| Date Issued : | June 11, 2024 | PCN Number : | 515347 |
| Reason for Change : | Manufacturing Process Change (Molex) | | |
| Description of Change : | This notification is to inform you about manufacturing process change for the part/s listed in this notice is changing. No changes will be made to product as part of this change. | | |

Before Picture

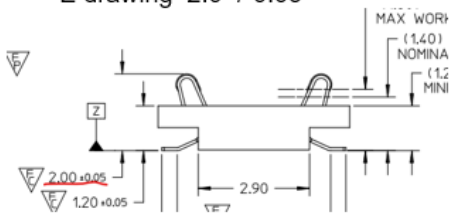
- Change the solder tail dimension

Before change :

E drawing 2.0+/-0.05

SD drawing

0.02+/-0.05

After change :

E drawing 2.0+0.11/-0.05

SD drawing

0.02+0.08/-0.02

- Optimized the solder tail dimension to improve CCD inspection pass rate.
- Product Impact:
No impact to fit, form, or function;
- Part Number Impact:
-See attached impacted part list
- Qualification Report and sample available upon request after the date shown above
